Drain-Improvement: SPRINGMILL VILLAGES DRAIN - THEMEADWS-SECTION 3A

RE: Springmill Village Drain, Section 3A The Meadows Arm

RE: Springmill Villages Drain-The Meadows-Section 3A

THE MEADOWS SPRINGMILL VILLAGES SECTION 3

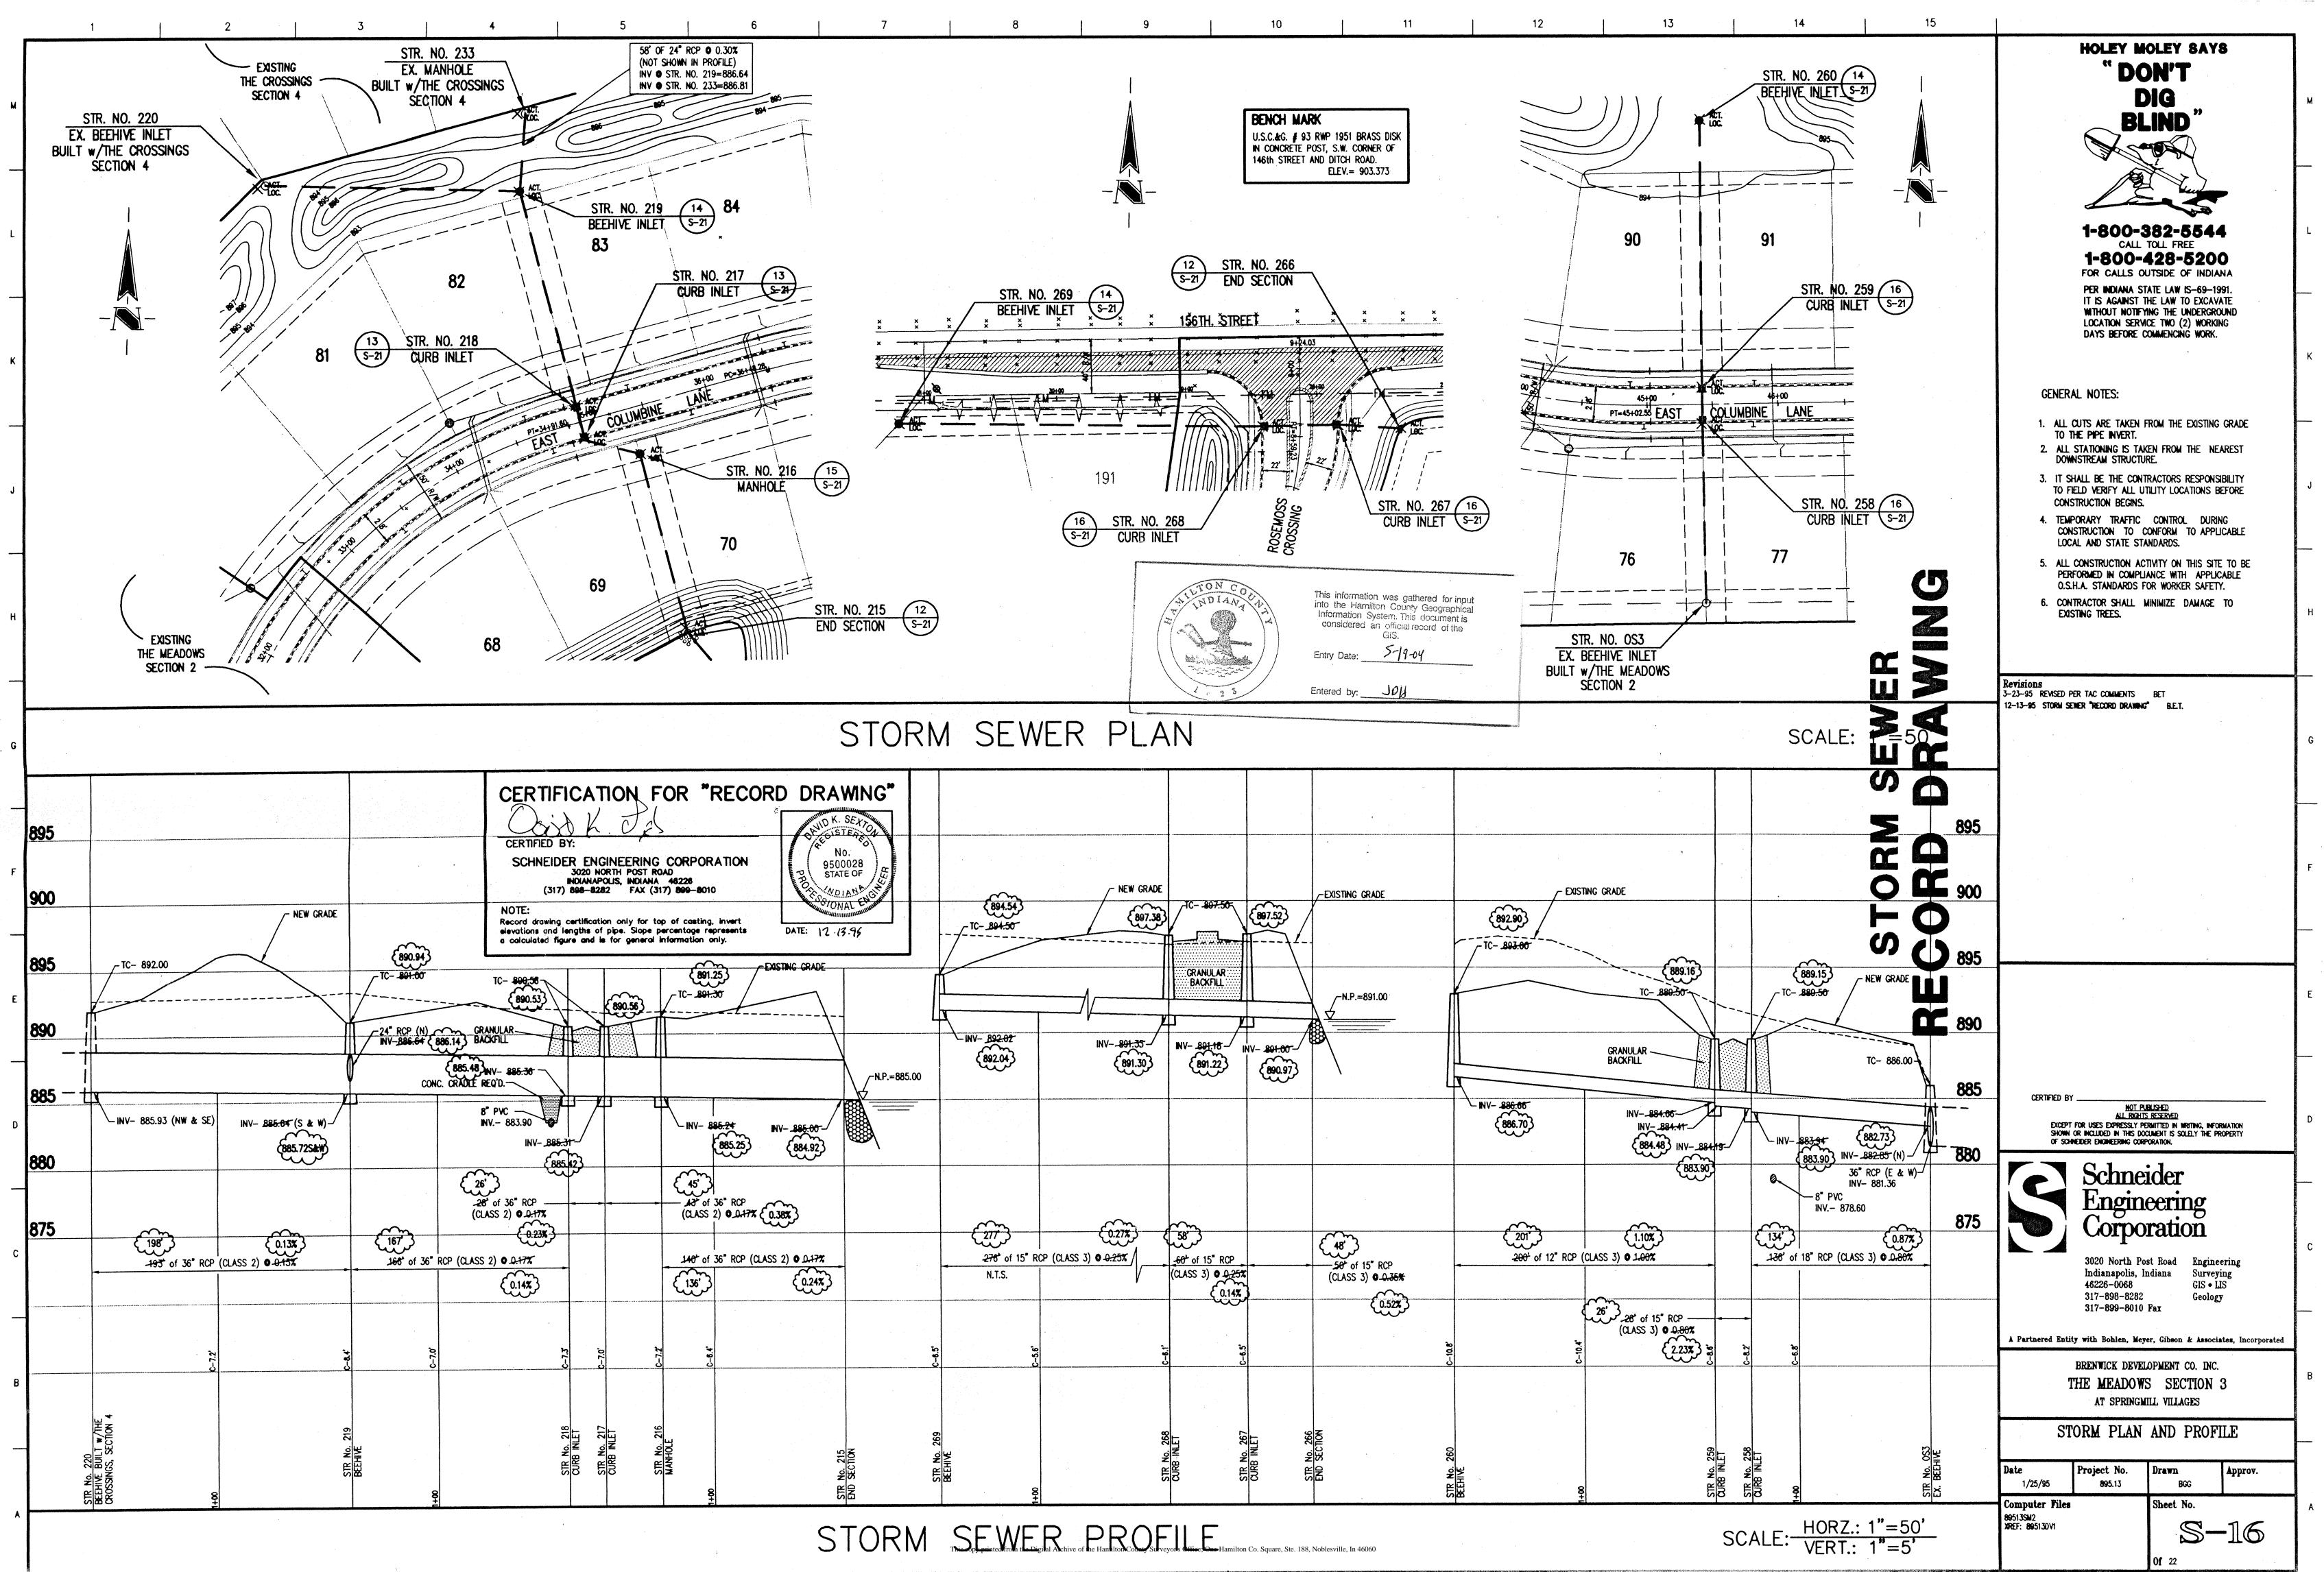
During construction, changes were made to the drain which will alter the plans submitted with my report for this drain dated January 9, 1996. The changes are as followed:

247			15"	RCP	shortened	from	28'	to	26	feet
STR	246	to	245	15"	RCP	lengthened	from	53'	to	55	feet
STR	256	to	255	15"	RCP	shortened	from	28'	to	26	feet
	240	-		24"	RCP	shortened	from	231	to	22	feet
STR	241	to	242	18"	RCP	lengthened	from	101'	to	102	feet
	242			18"	RCP	lengthened	from	101	to	102	feet
STR	243	to	244	18"	RCP	shortened	from	28'	to	26	feet
	244			18"	RCP	lengthened	from	117'	to	118	feet
\mathbf{STR}	245	to	257	12"	RCP	shortened	from	174	to	173	feet
STR	267	to	268	15"	RCP	shortened	from	60'	to	58	feet
STR	268	to	269	15"	RCP	lengthened	from	276'	to	277	feet
STR	215	to	216	36"	RCP	shortened	from	140'	to	136	feet
STR	216	t.o	217	36"	RCP	lengthened	from	43'	to	45	feet
STR	217	to	218	36"	RCP	shortened	from	28'	to	26	feet
STR	218	to	219	36"	RCP	lengthened	from	166'	to	167	feet
STR	219	to	220	36"	RCP	lengthened	from	19 3'	to	198	feet

The length of the drain due to the changes described above is now 5,329 feet.
